RE: 2630 Grand River – Application Review Comments

SAFEbuilt Site Plan Review Letter, dated February 15, 2022:

Tetra Tech Review Letter, dated February 17, 2022: General

Brighton Area Fire Authority Review Letter, dated February 16, 2022:

Landscape Plan

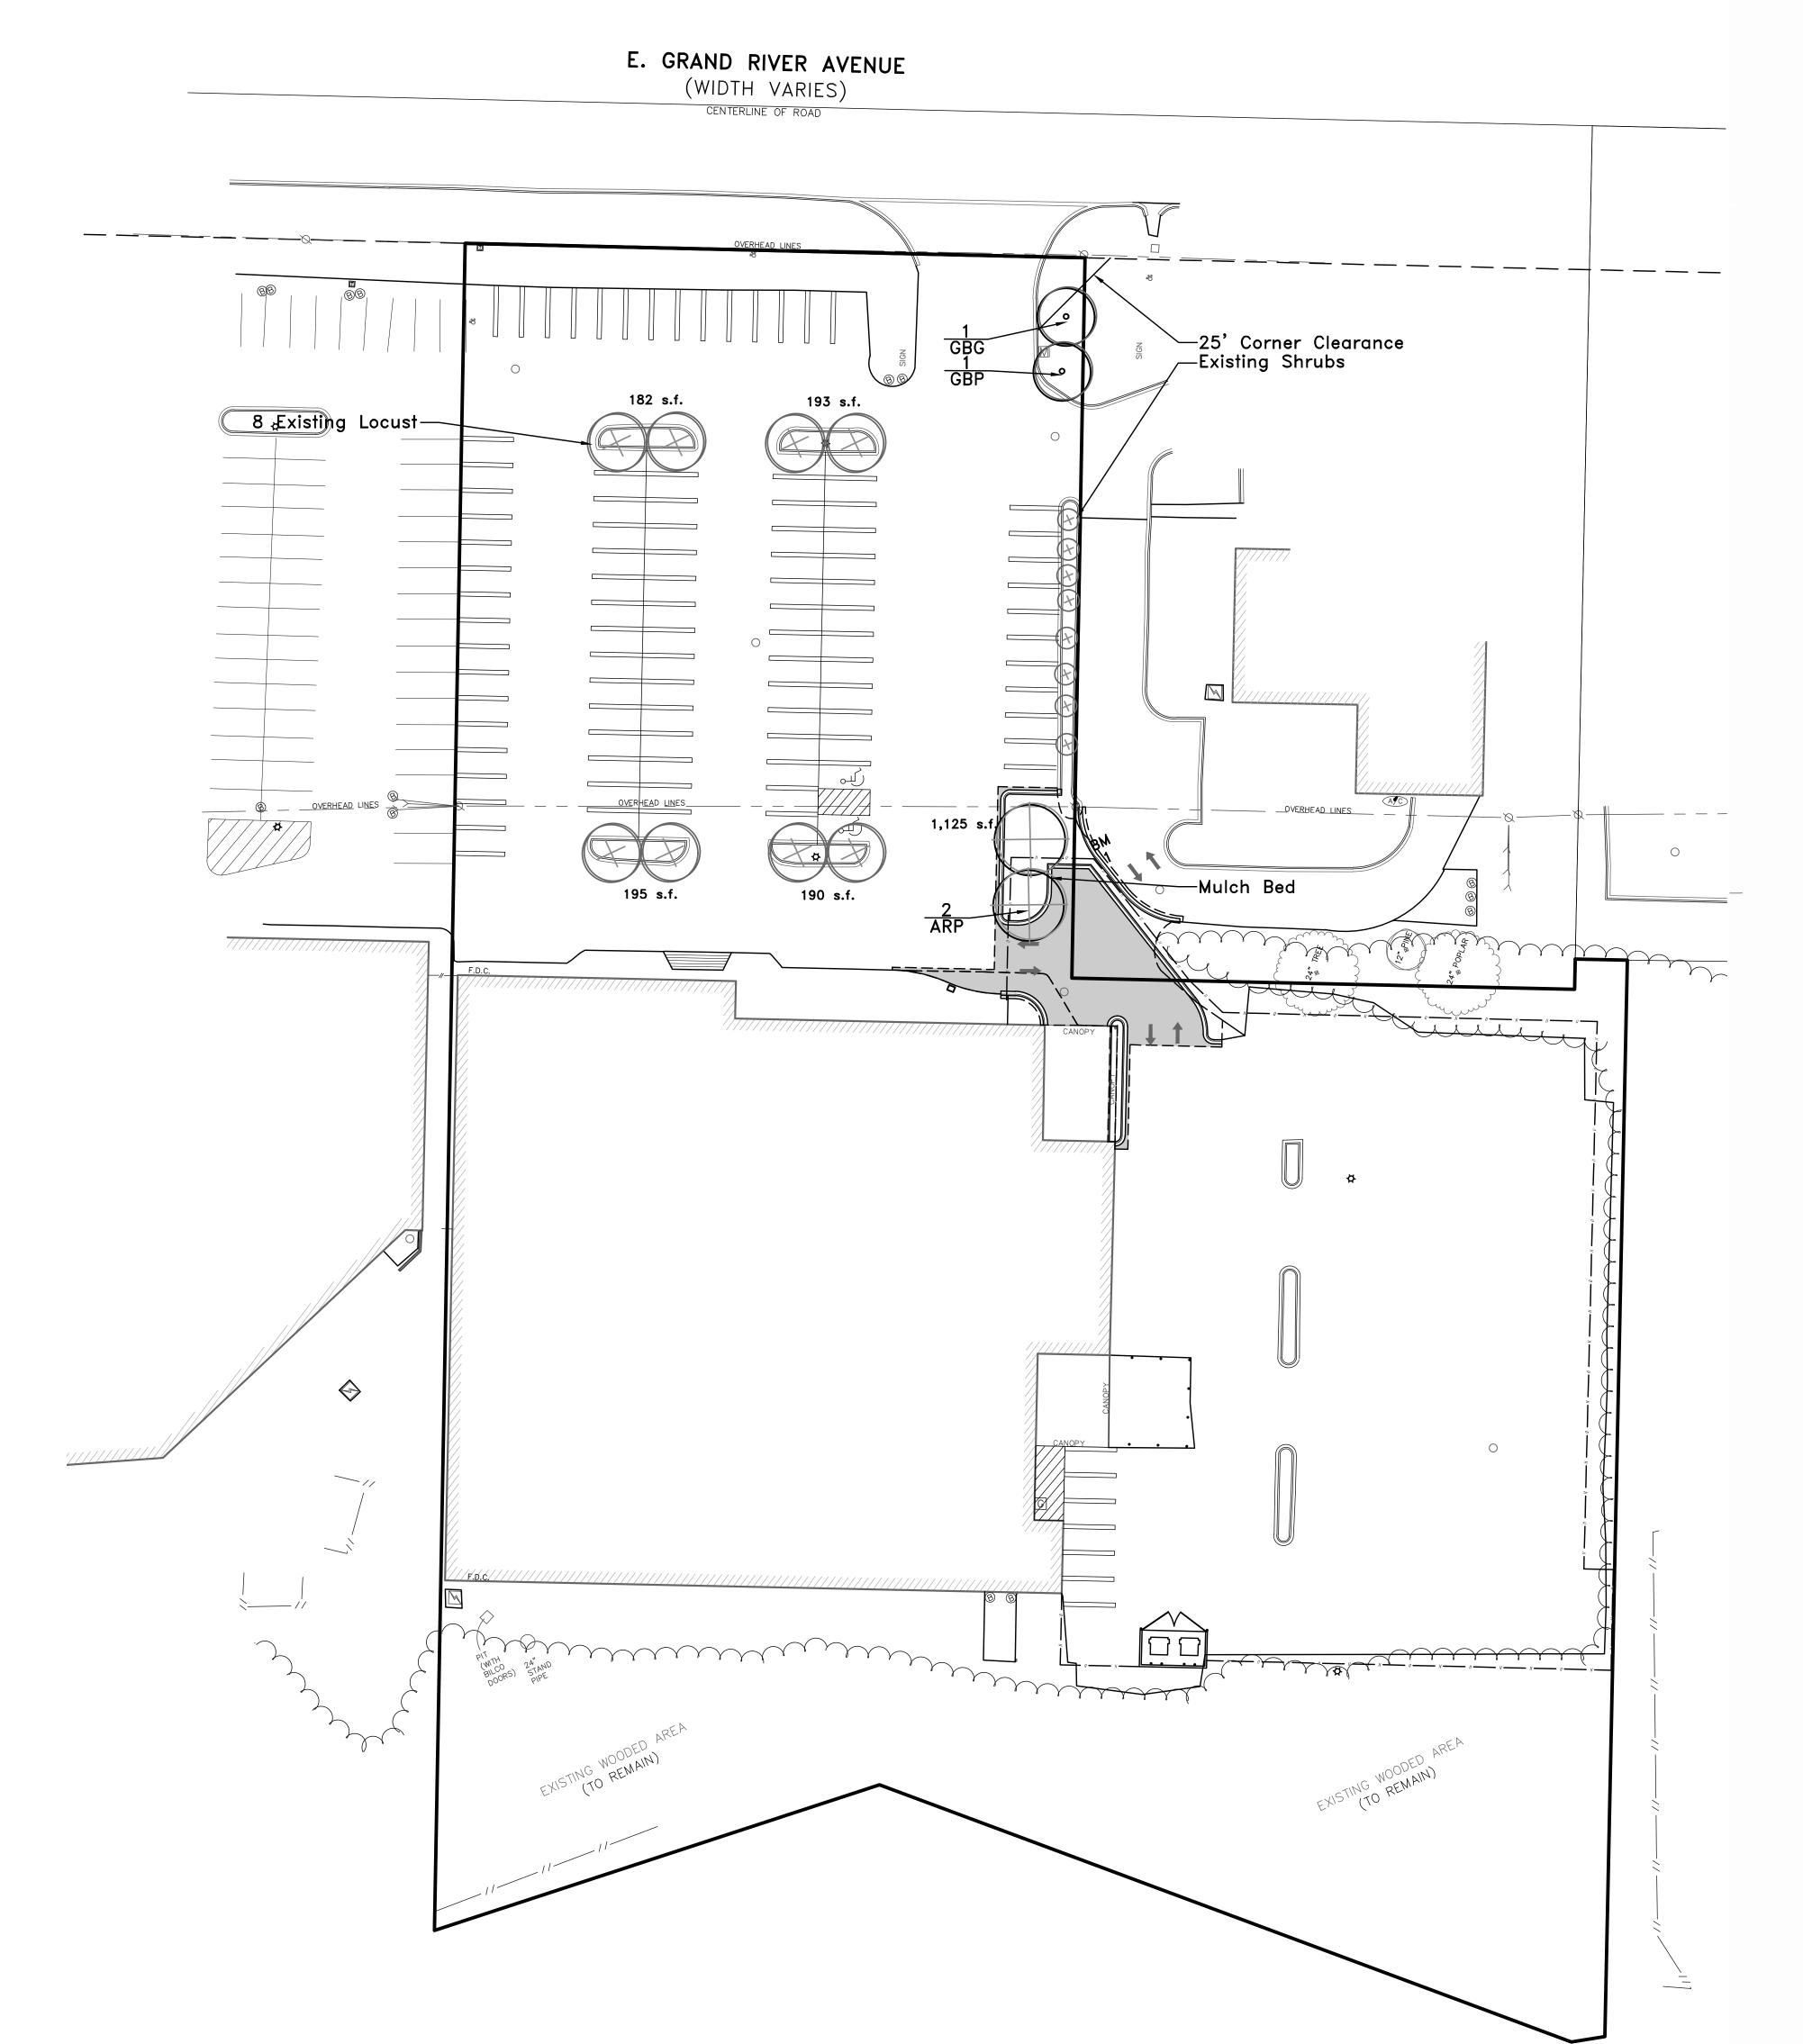
- d. Noted. It is not feasible to incorporate more landscaping than we have proposed in the Greenbelt due to space requirements and the presence of underground utilities. We are adding (3) trees to the parking area and thus meet that requirement of the ordinance. Also, as noted, there is a large existing woodland and heavily vegetated buffer at the South and East borders of the property.

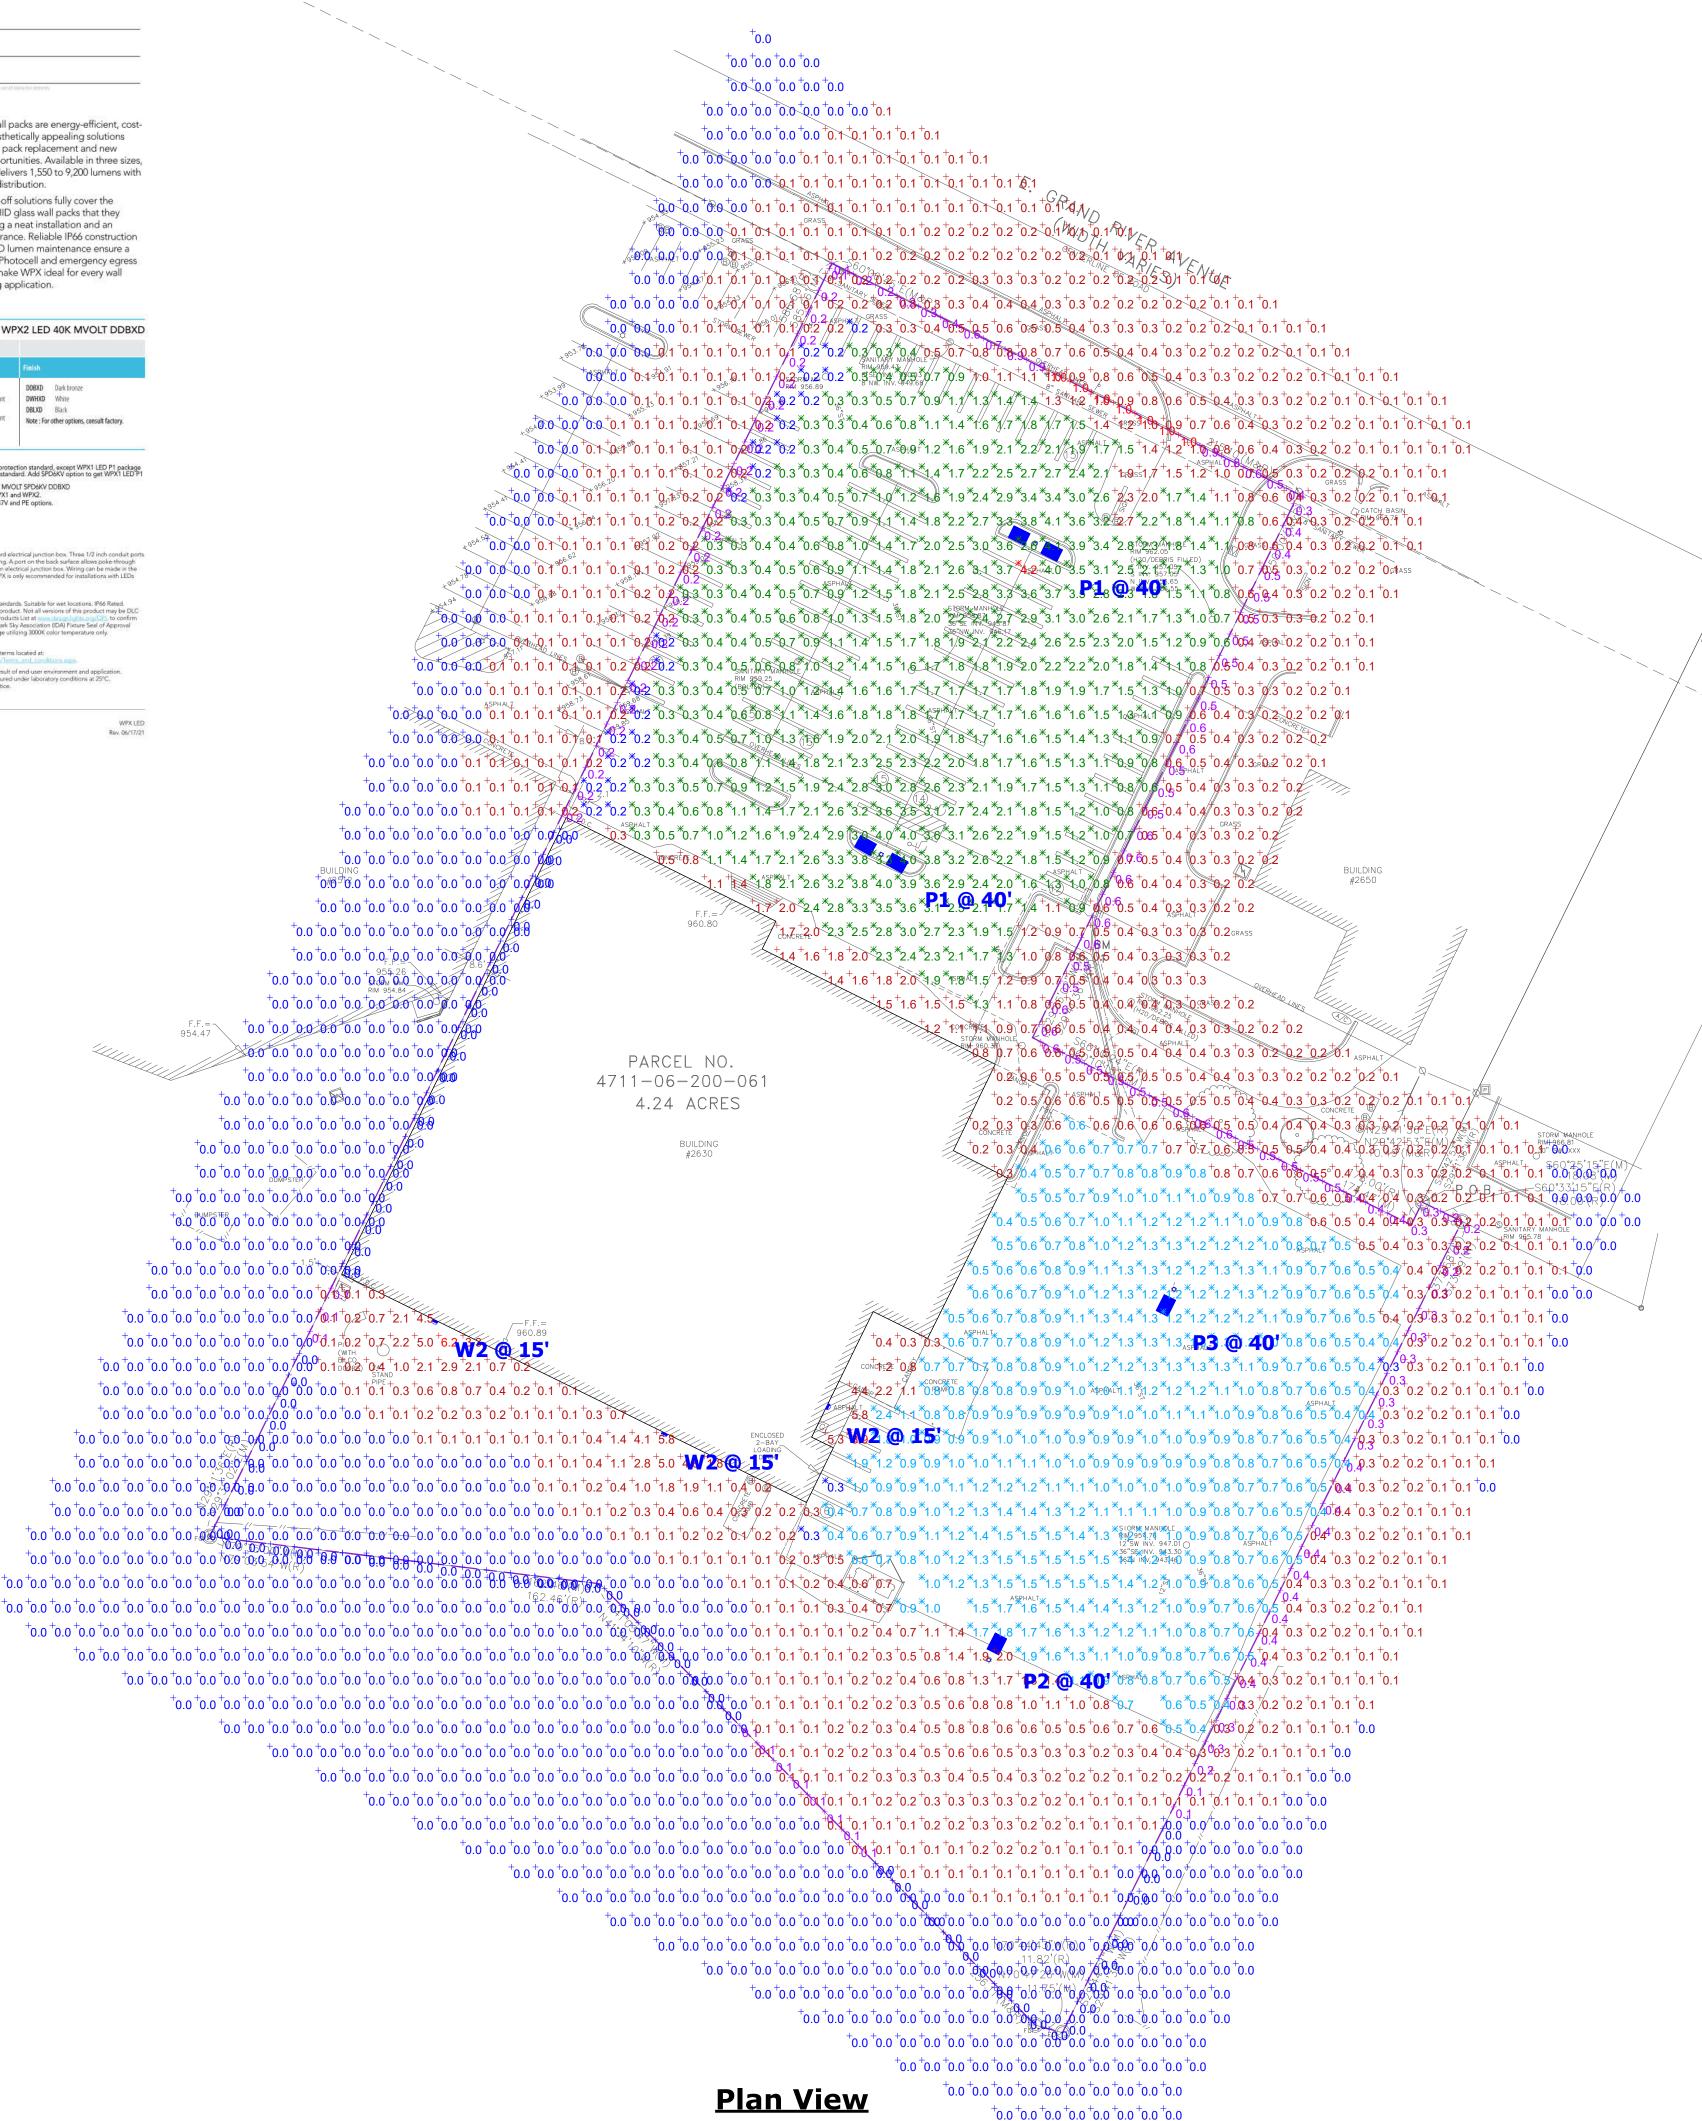
- e. There are (4) existing light poles at the property. We have proposed to upgrade these fixtures to modern, energy efficient, LED fixtures. As the poles are existing, we would request that the Commission allow for their continued use. Light fixtures will be positioned so that they do not cast any light across the property lines as shown.
